FLORIDA GATEWAY COLLEGE

Addendum Two

ITB #21-3-01 – Olustee Armory Building

This Addendum has been issued to address vendor questions.

DIVIDER WALL SECTIONS AND DETAILS

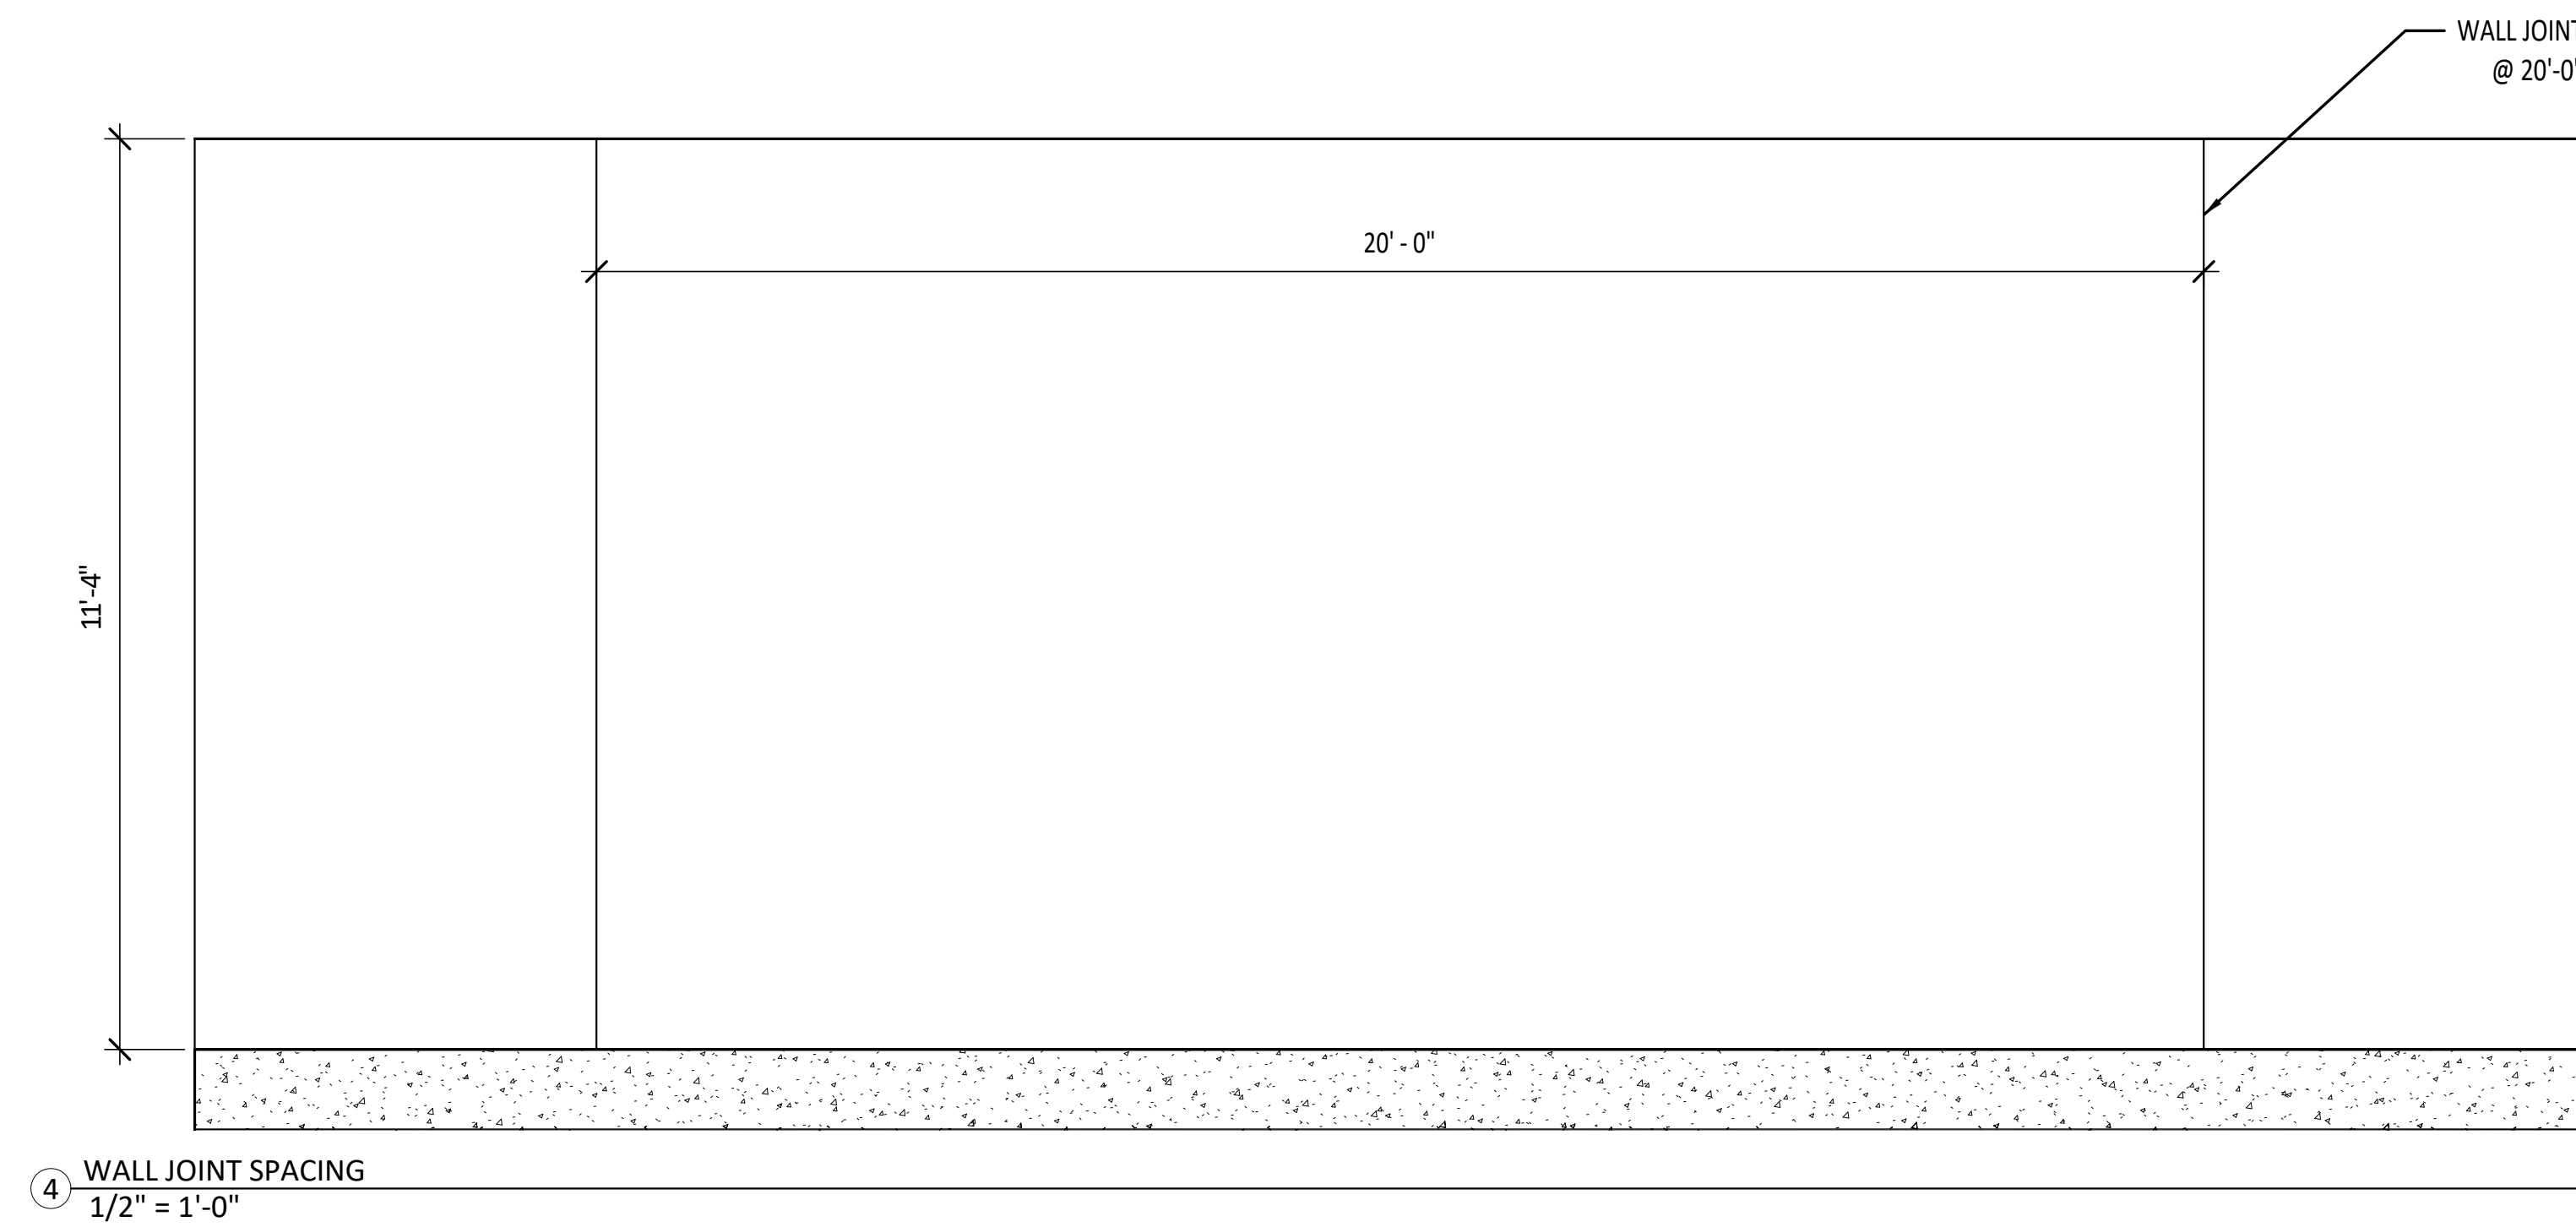
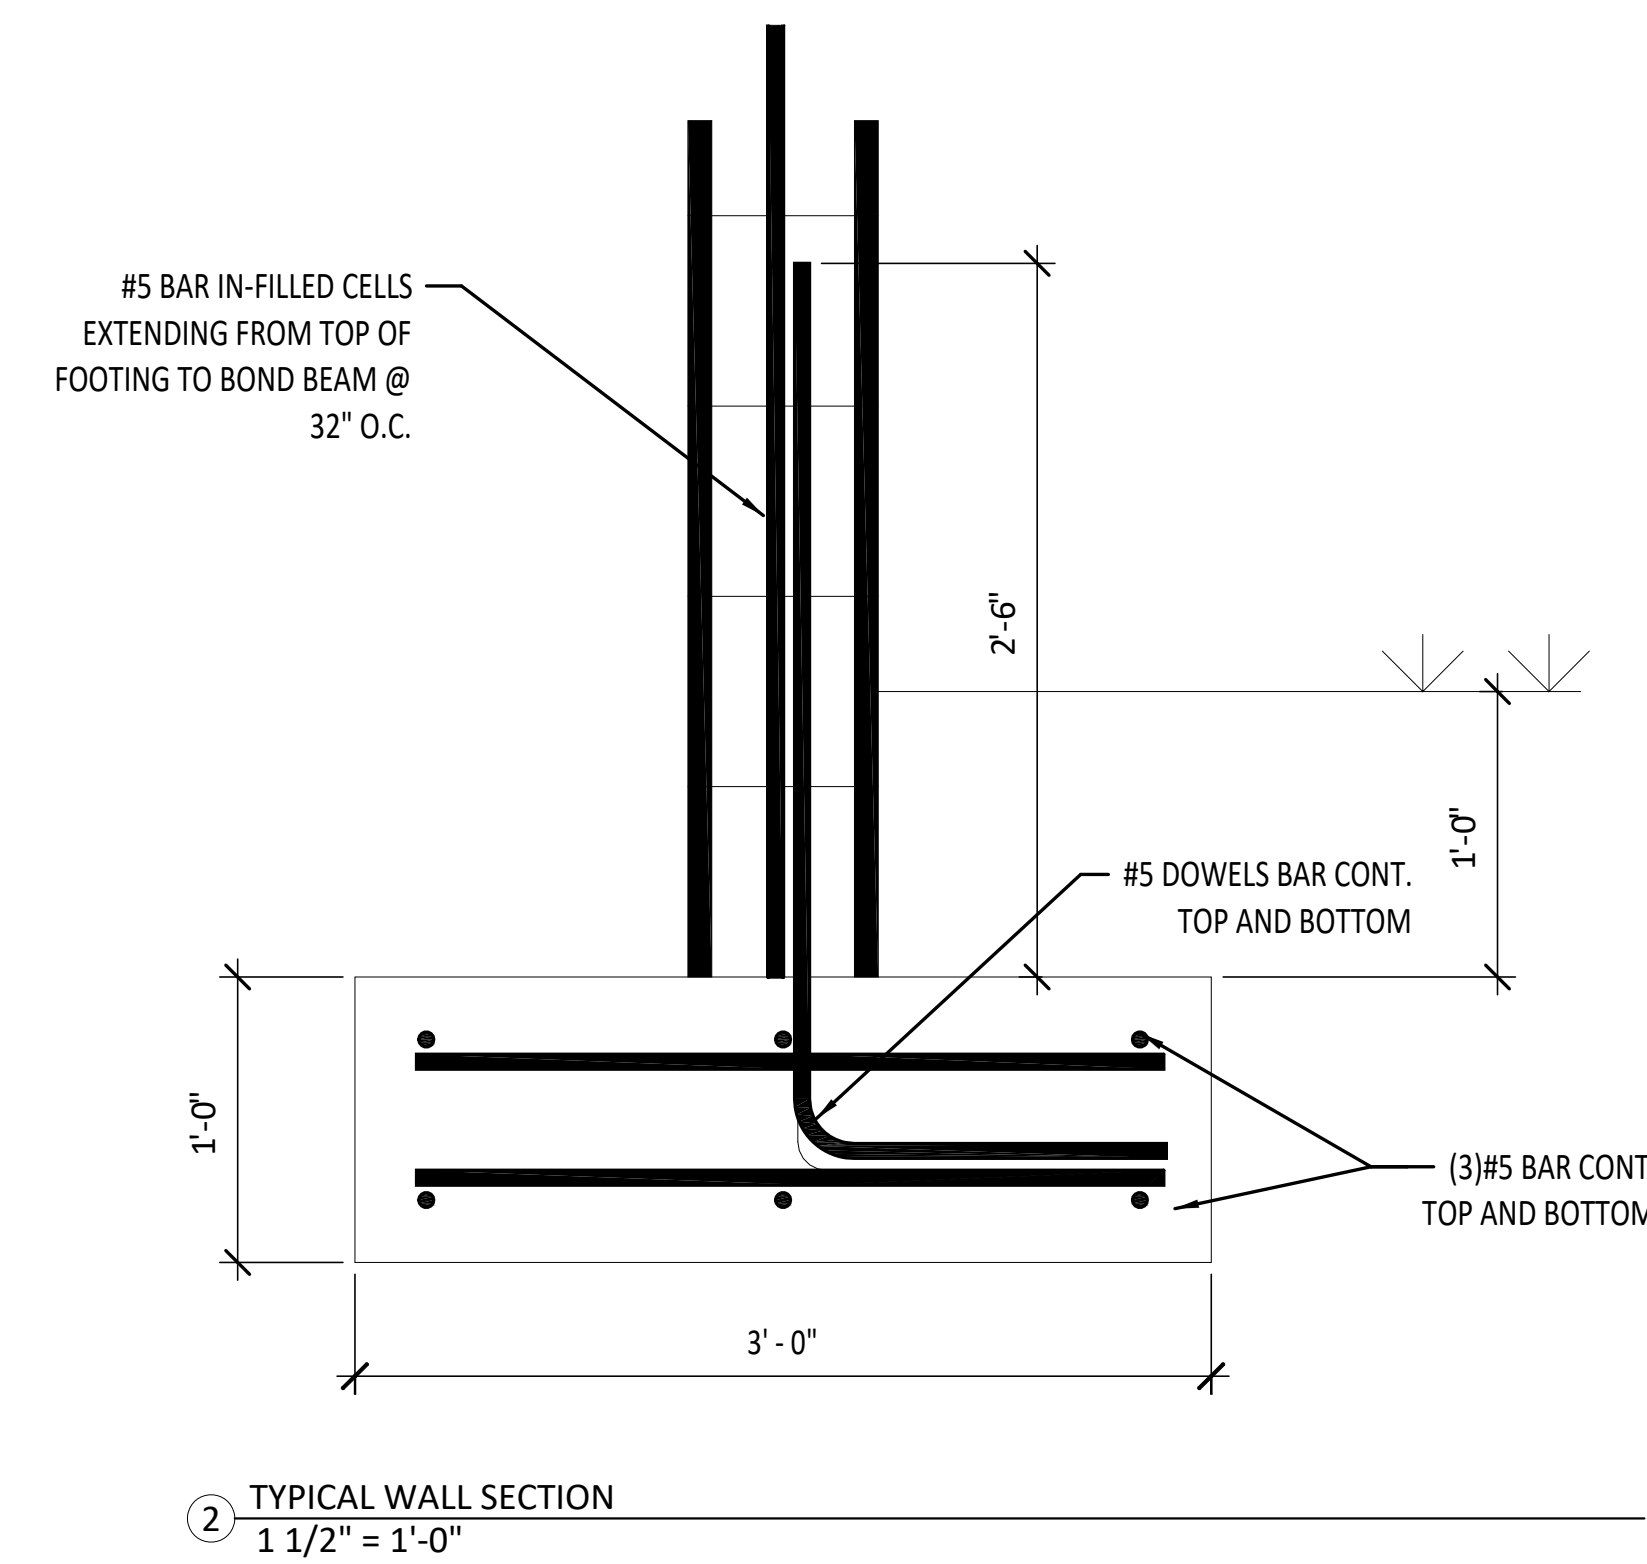
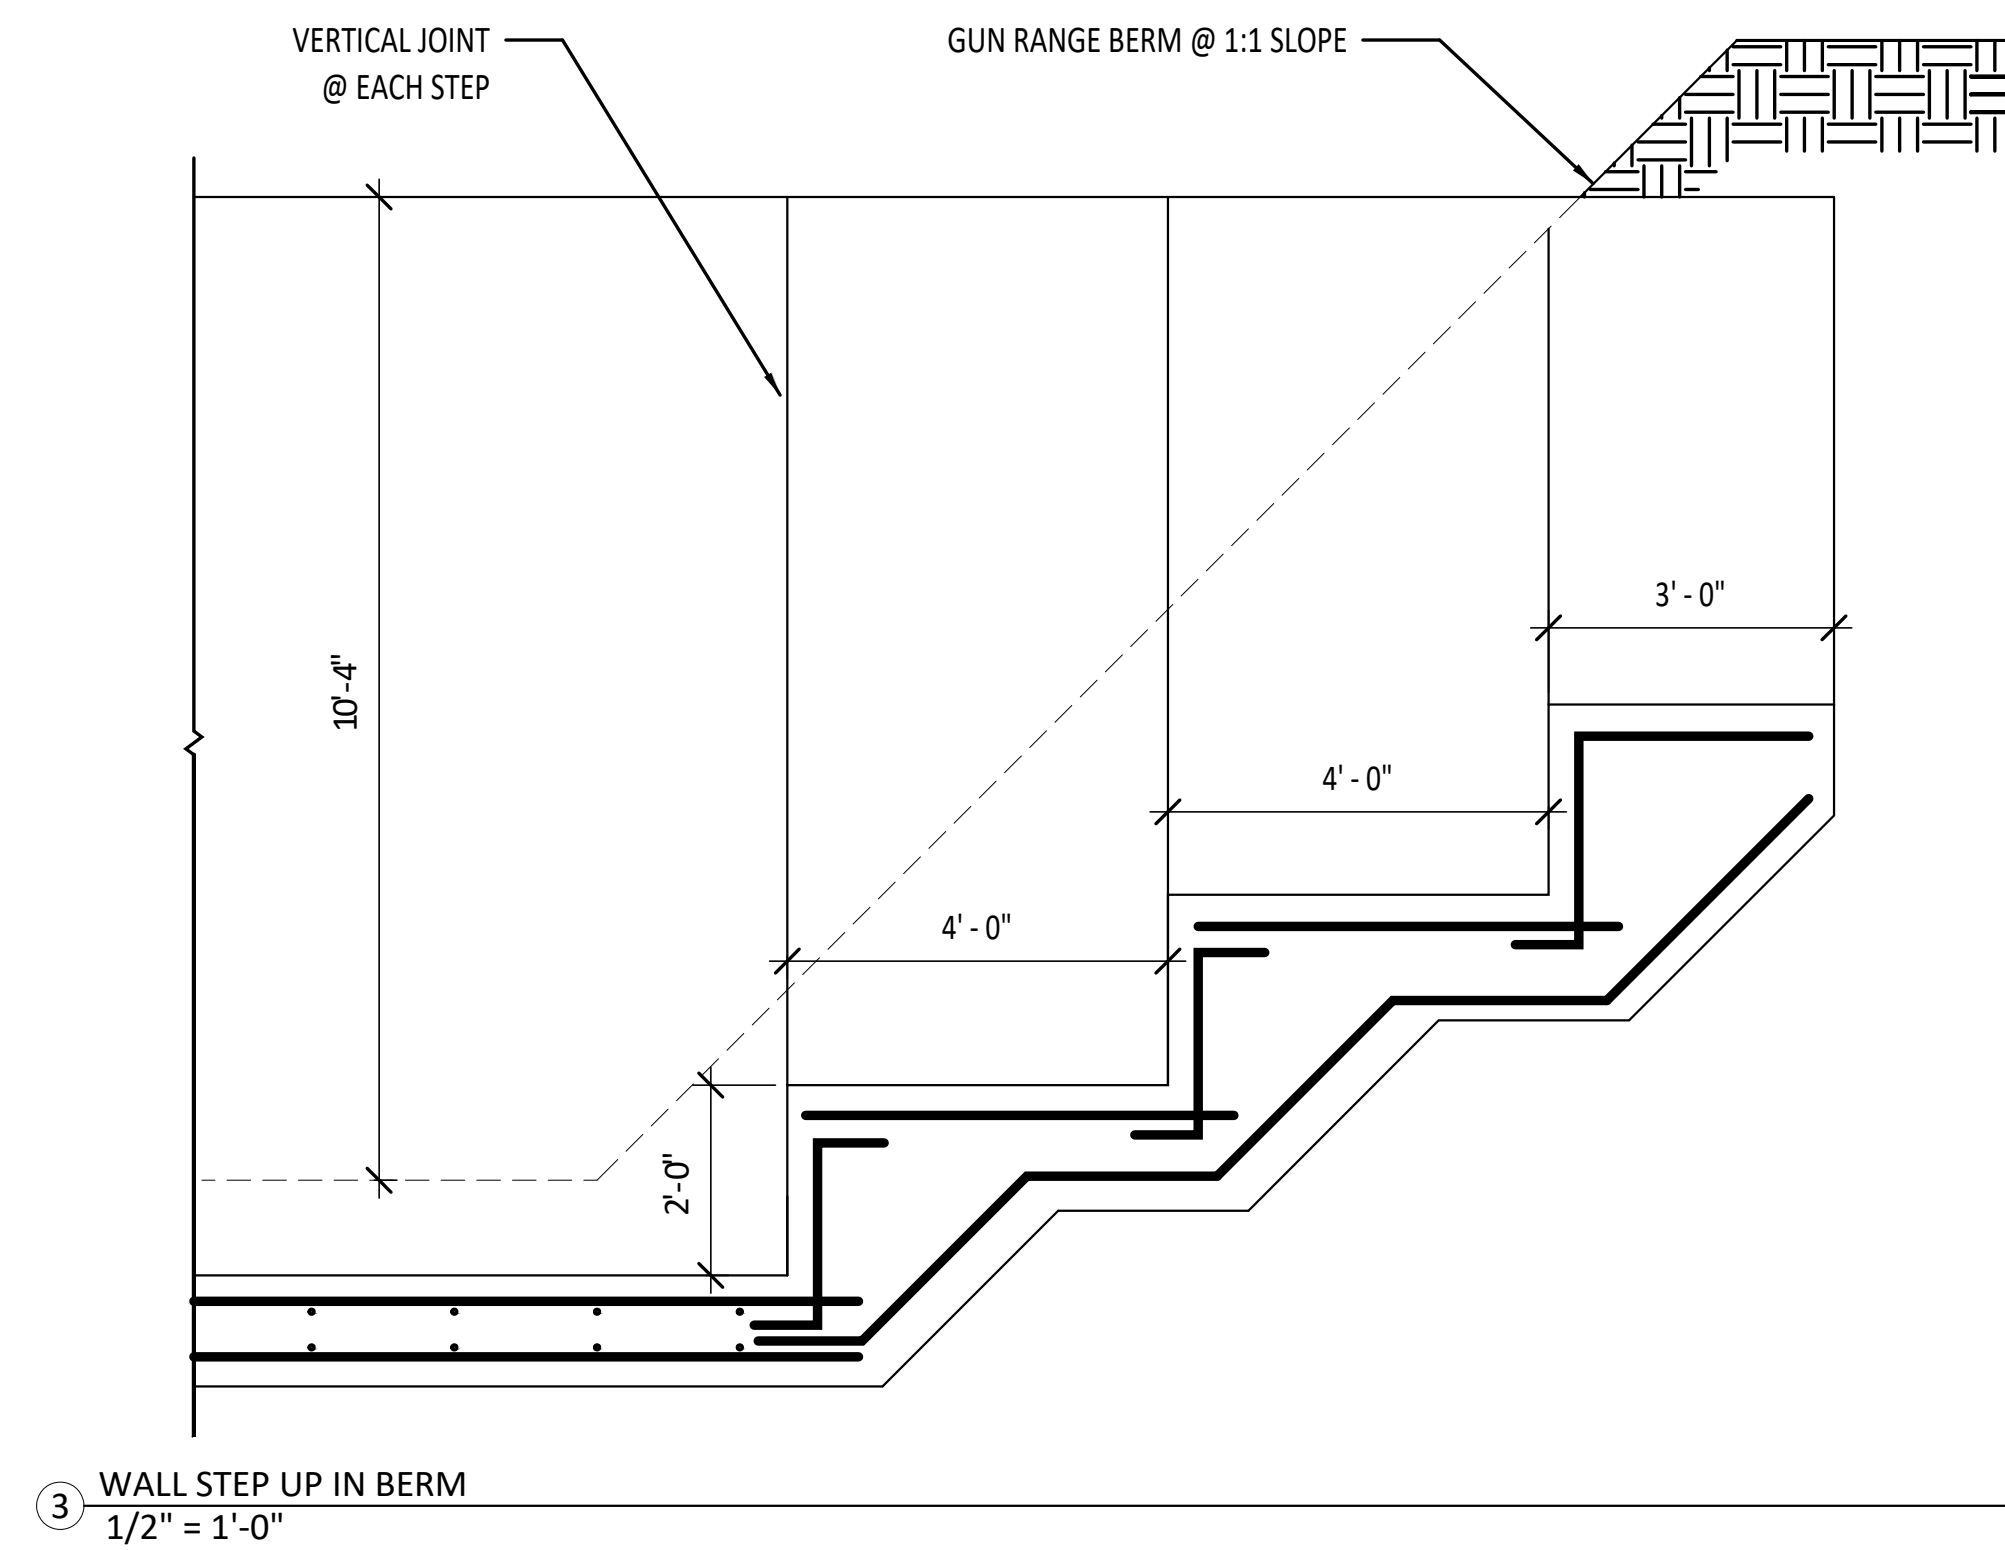
Question 1: What is the structural design of the base of the masonry wall?

Answer: See detail 2 of the attached block wall drawing.
